**Particle Physics Division
Mechanical Department Engineering Note**

Number: MD-ENG-03-026

Project: NuMI

Title: Rails between target hall and access shaft

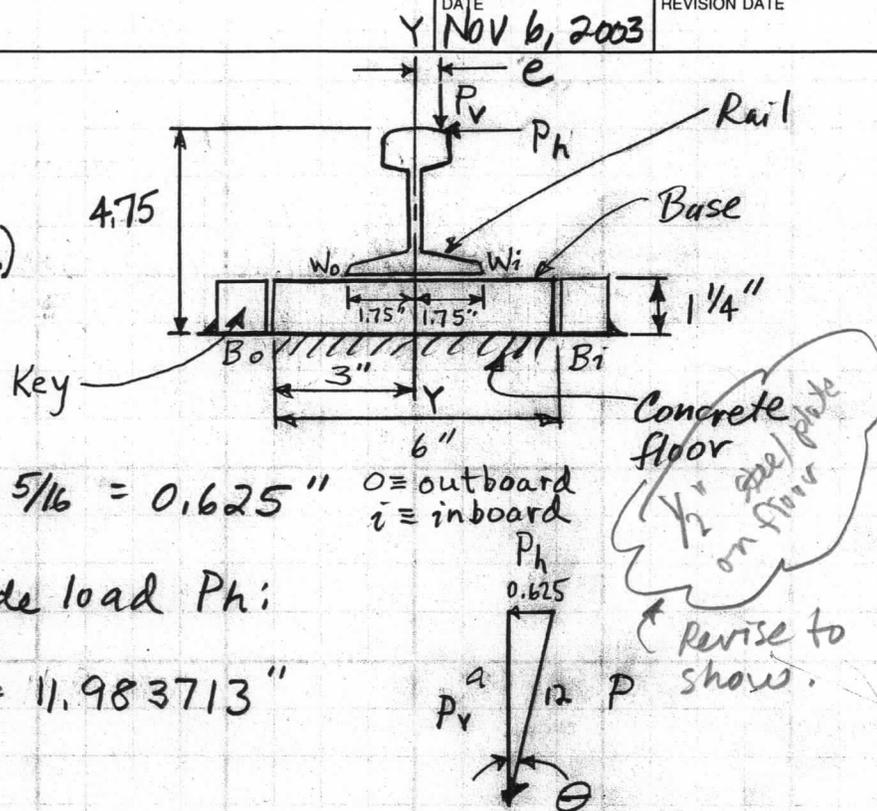
Concrete floor
1/2" steel plate
on floor
Revise to show.
